TIAA Superfund Site, Area A & B Groundwater OU - Record of Decision Amendment

**Tucson International Airport Area
Superfund Site
Tucson, Arizona**

**Former West-Cap of Arizona and West Plume B Project Areas
Area A & B Groundwater Operable Unit**

RECORD OF DECISION AMENDMENT

Figure 1

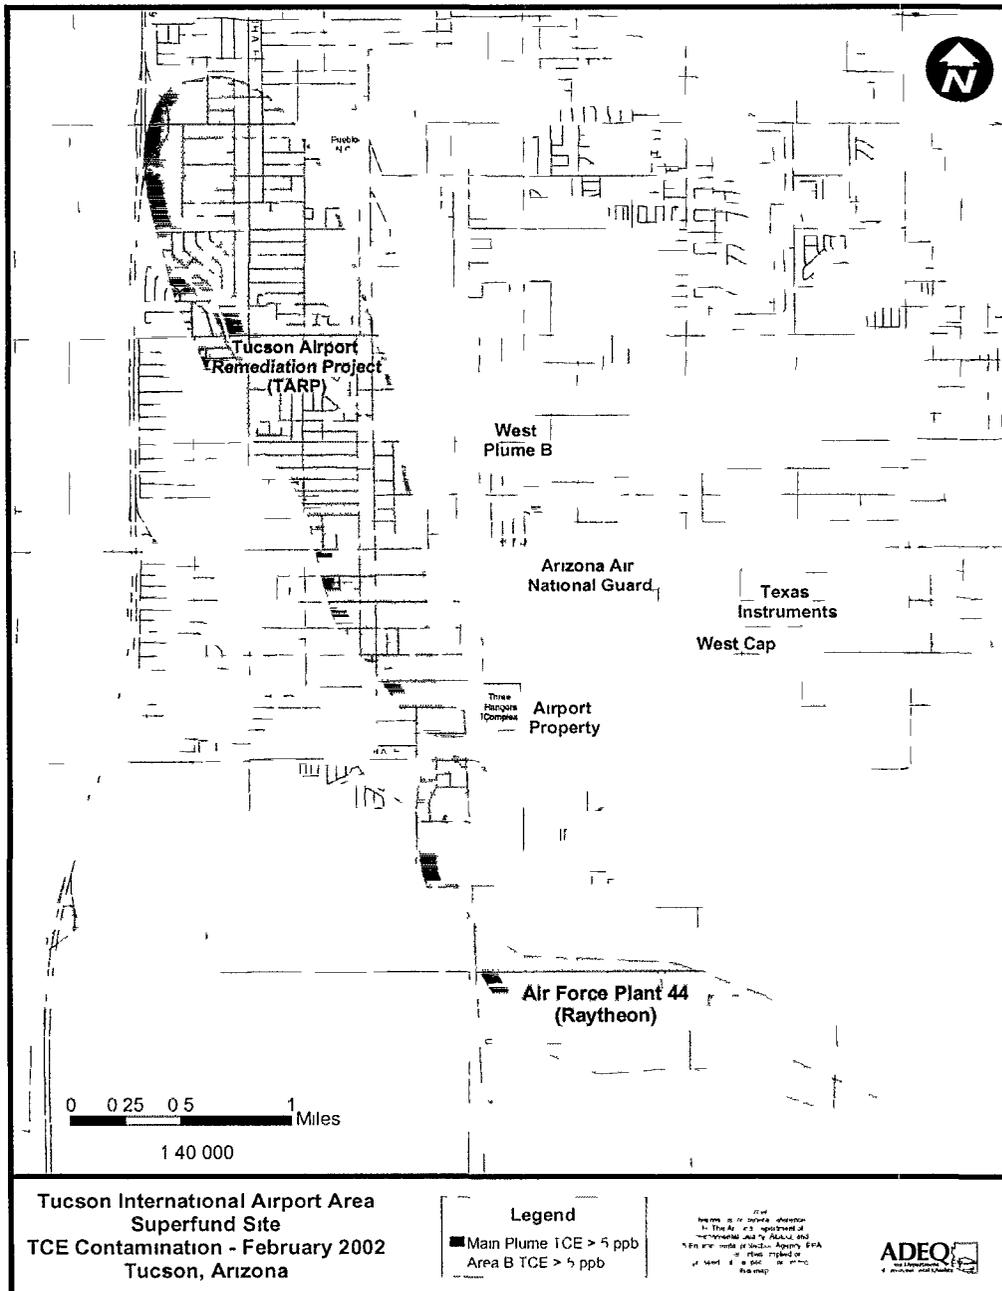
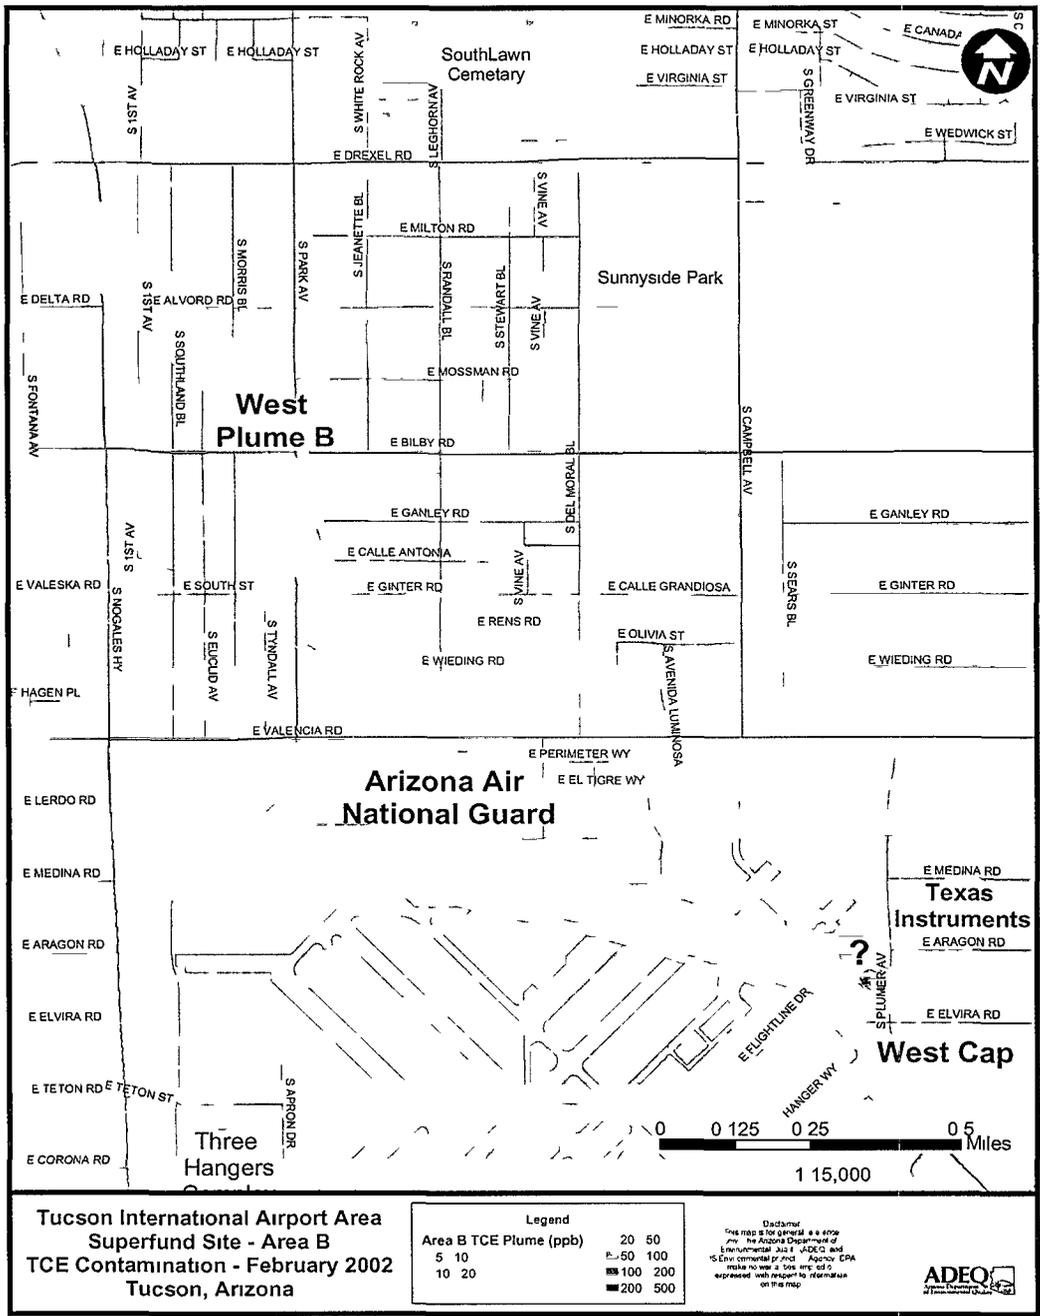
AANG Comment 4: TCE concentration contours presented to the public should consist of recent data. The data shown is from February 1999, which is over three years old. Data is currently available from nine sampling rounds conducted since February 1999.

Response: Comment noted. TCE concentration contours showing the entire TIAA Site (Figure 1) and the magnified view of West-Cap, AANG and West Plume B (Figure 2) have been updated by ADEQ using February 2002 data. EPA considered data up to June 2004 in selecting the remedy in this ROD Amendment.
